Delaware Department of Transportation  
**QUESTIONS AND ANSWERS**  
**T201280102.02**  
**STATEWIDE HOPPER RACKS**  
**Monday, March 11, 2013**

TYPICAL ROOF FRAMING PLAN

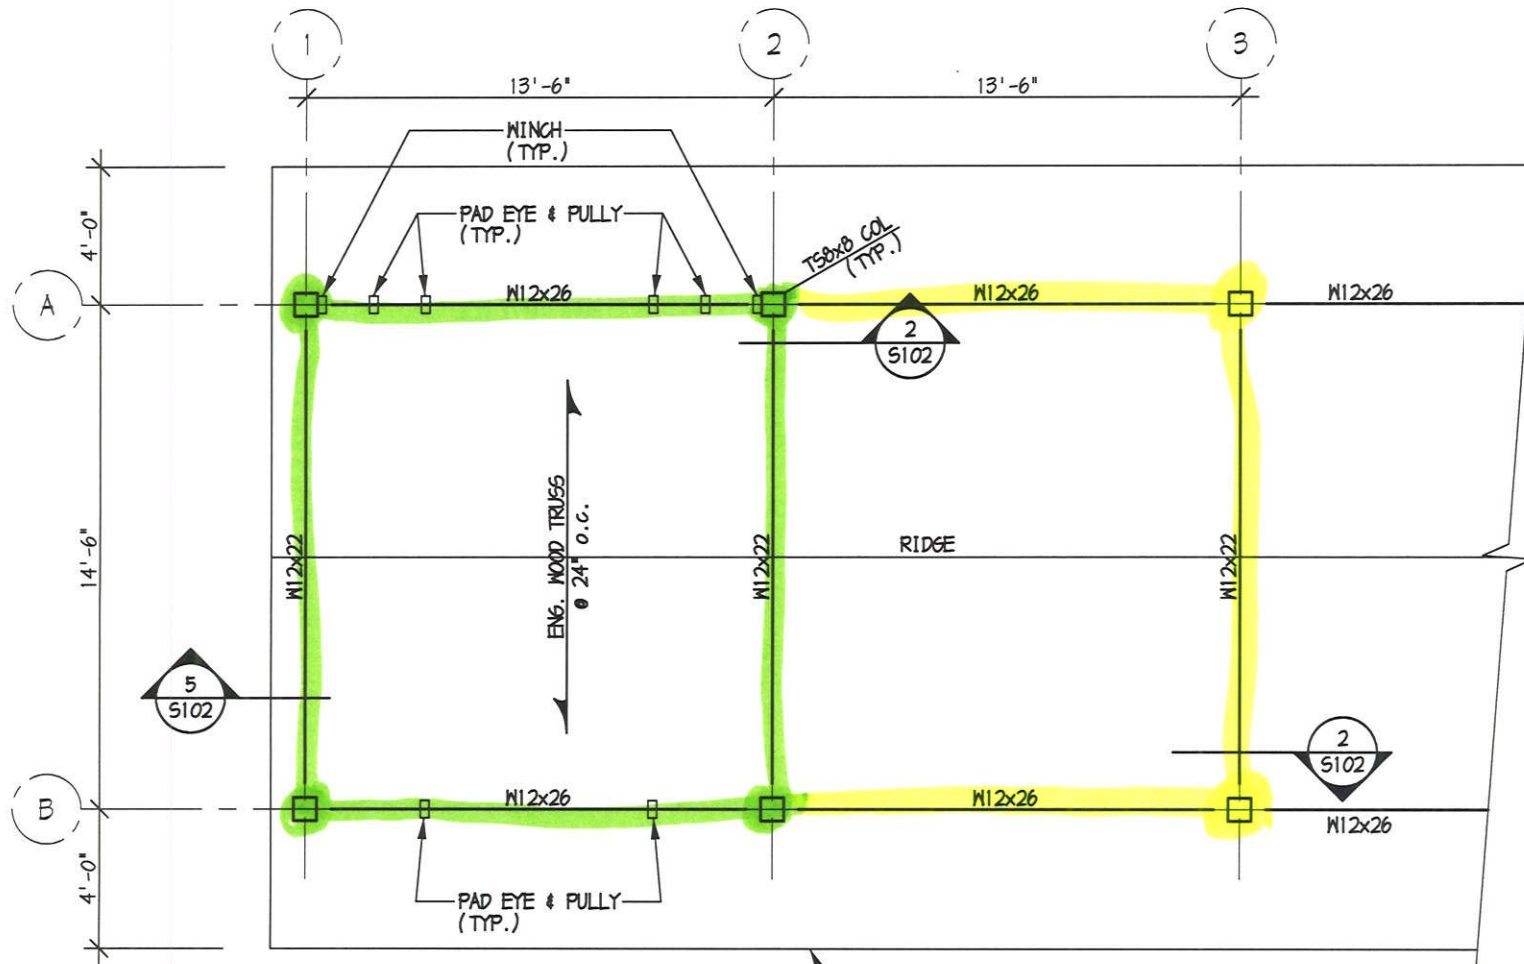
6	Addendum #1, Response to question 3 indicates no roof is required for locations 4 and 5 of breakout sheet; however, location 4 of section 763569-Building clearly states "with roof system" as does location 5. Can we assume the information issued as answers to questions are correct or will an addendum modify the bid documents to correctly state the scope of work?	The special provision for 763569 - Buildings will be revised in upcoming addendum.
5	Bid Item 763569 Buildings, Descriptions, Location 4, indicates to provide pricing for 1 base bay hopper rack with roof system. Is that 1 bay added to any 8 or 12 bay structures requiring two additional columns and one 13'6" section of roof or is that to be an additional 8 bay structure?	See response to question 4.

Q #	Question	Answer
4	Locations 4 and 5 of Breakout Sheet 1 refer to "Base Hopper Rack Bay" and "C shaped Add on to Base Bay". Please provide definitions for each on these items and what is to be included in each of them.	<p>Location 4 is intended to be the unit price for one square bay, to be used as the price for the first hopper bay in a row at any add-on locations. This includes the footings and steel but no site work (outside the actual construction of the posts) or roof systems (except holes drilled for future roof systems, like Magnolia).</p> <p>Location 5 is for each subsequent bay connected to a location 4 bay at the particular add-on location. Because the "base" unit would already be included (as "location 4"), only three sides would essentially be needed (which is why the term "C" shaped was used in the specifications). Again this includes the footings and steel but no site work (outside the actual construction of the posts) or roof systems (except holes drilled for future roof systems, like Magnolia). Please note, we must have a location 4 bay first before we can add additional location 5 bays. There is however no limit to how many location 5 bays that can be added to any given location 4 bay. This was also described on page 9 of the pre-bid transcript.</p>
